Brent Decommissioning Derogation: An evaluation

**The Ministry of Infrastructure and Water Management
Government of The Netherlands**

an independent evaluation group

4 October 2019

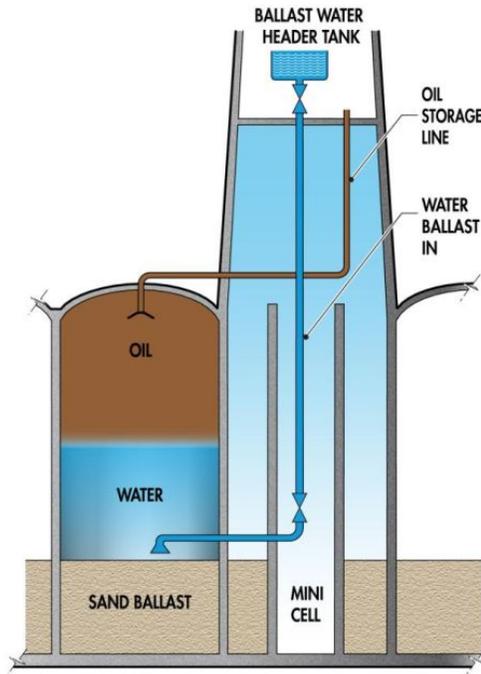
Page 22: Figure 7 shows the general arrangement of drawdown system and the piping system that goes into the cells (see also Figure 10).
